## GLEN EIRA CITY COUNCIL

CARNEGIE DRAFT STRUCTURE PLAN  
RAW FEEDBACK  
STAGE 6 - OCTOBER – DECEMBER 2017

Shop-top (standard)

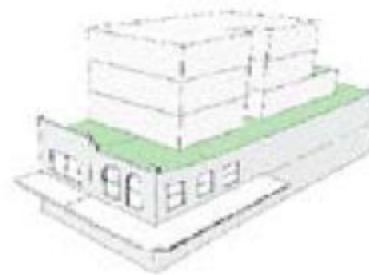
The Buildings Types have now been expanded from the previous 9 Types (Draft Concept Plan) to 10 Types, while their proposed height and graphic depicts have also been refined. The additional building type being 'Urban apartment', which is defined as an 'apartment building within a dense urban setting.

Further the 3D illustration of the building types has evolved and been graphically refined (since the Draft Concept Plan). In relation to shop top we note that the new depiction shows a 2 storey streetwall (presumably a retained façade) with a setback to a 3 further upper levels. Overall it shows a 5 storey form, which is consistent with the previous depiction, however the massing arrangement has changed from a 3 storey streetwall with 2 recessive upper levels to a 2 storey streetwall with a 3 recessive upper levels. It is unclear as to why the massing profile has been refined and there is no explanation within the document.
